84 LUMBER COMPANY SITE DEVELOPMENT

SP# 09-22

STAFF REPORT #5

August 23, 2023

Figure 8. Location of Barrier

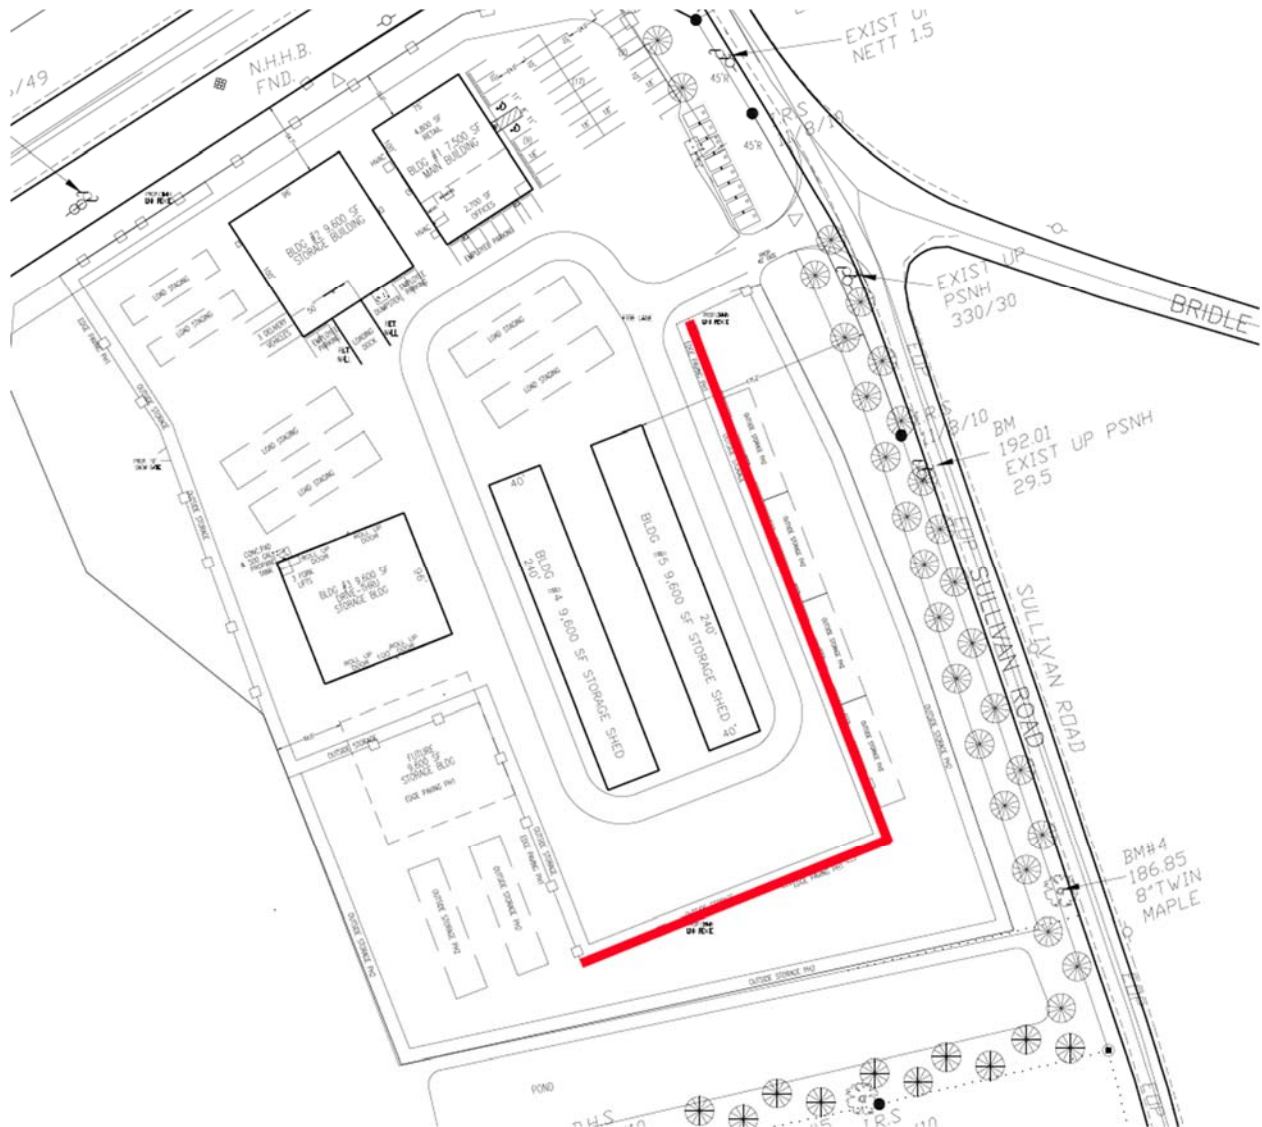
- An acoustic barrier outlined in appendix C of the study and shown on the site plan is installed per the manufacturer's recommendations.
- Forklifts are equipped with ambient sensitive white noise back up alarms.
- Propane Forklifts be utilized on site.
- Idling laws are enforced for Heavy Trucks/Tractor Trailers
- Tractor Trailer or other Heavy Trucks are not present on Saturday.

A waiver request for the 100-foot buffer (§276-11.1 B(12)c) is pending. As part of this, the Applicant has made arrangements with the abutting resident and has added acoustic fencing to the plan. The Board may wish to consider the waiver request while also reviewing the plan updates with the Applicant.
